187th session

**1958 Agreement:**

### **Proposal for Supplement 8 to the 03 series of amendments to UN Regulation No. 48 (Installation of lighting and light-signalling devices)**

**Submitted by the Working Party on Lighting and Light-Signalling\***

“Annex 4

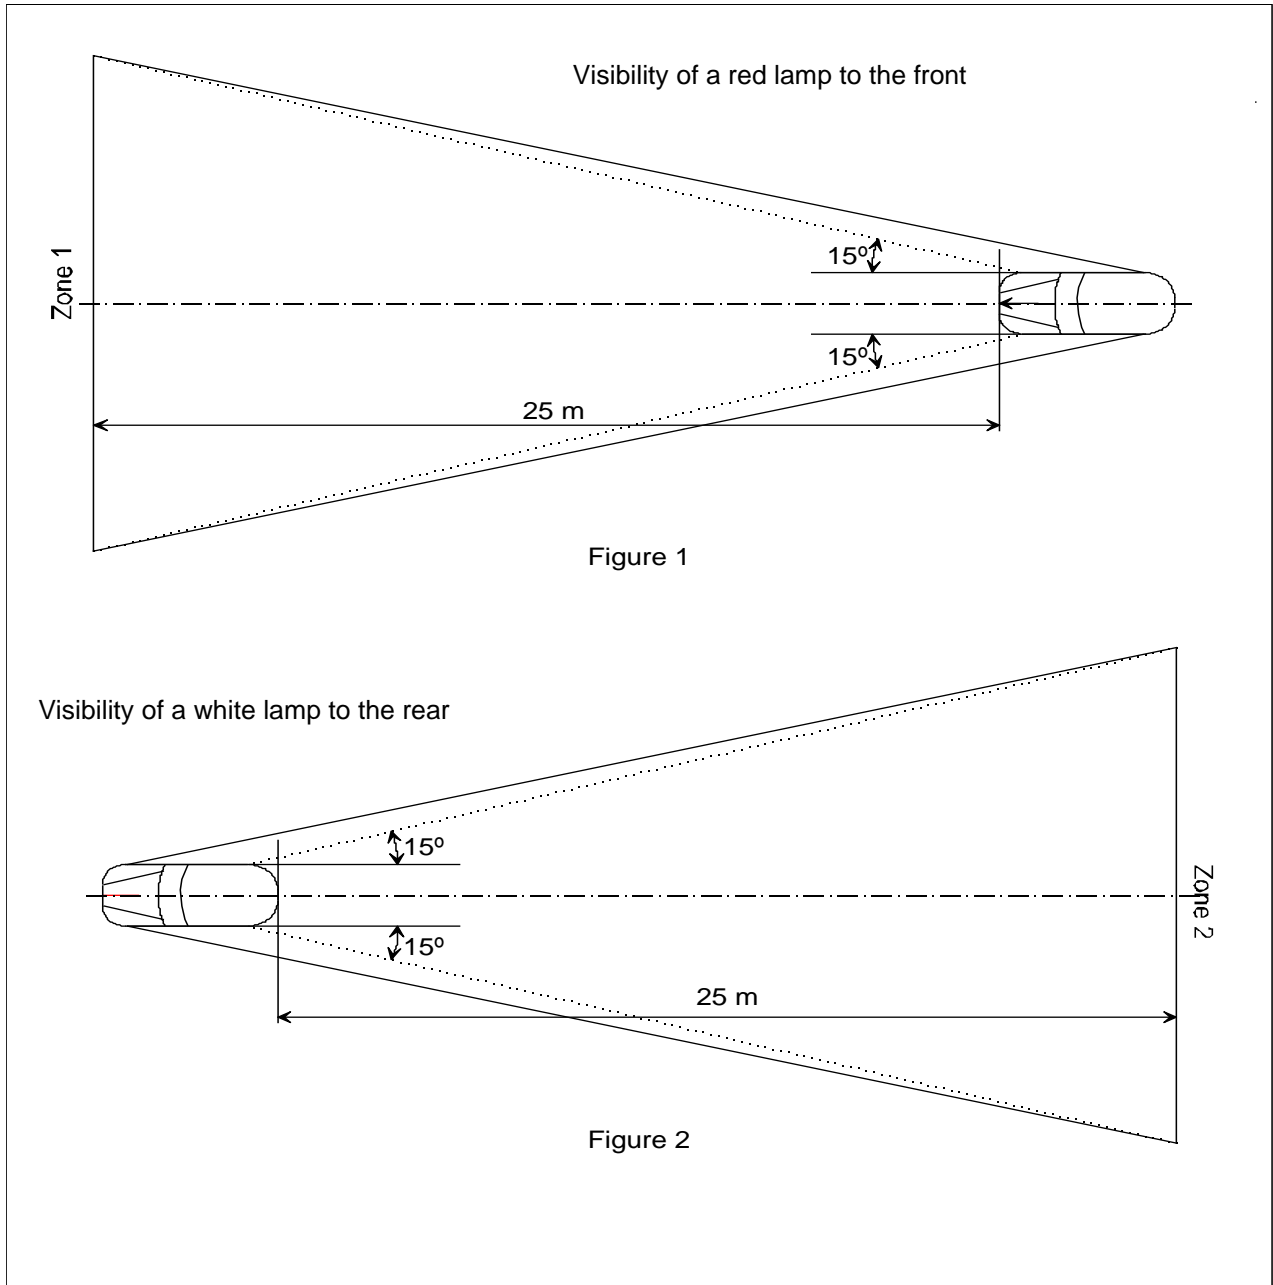
*Annex 4, amend to read:*

**Visibility of a red lamp to the front and visibility of a white lamp to the rear**

(See paragraph 5.10.4. of this Regulation)

In their respective planes, the zones 1 and 2 explored by the eye of the observer are bounded:

- In height, by two horizontal planes 1 m and 2.2 m respectively above the ground;
- In width, by two vertical planes which, forming to the front and to the rear respectively an angle of 15° outwards from the vehicle's median longitudinal plane, pass through the point or points of contact of vertical planes parallel to the vehicle's median longitudinal plane delimiting the vehicle's overall width; if there are several points of contact, the foremost shall correspond to the forward plane and the rearmost to the rearward plane.”
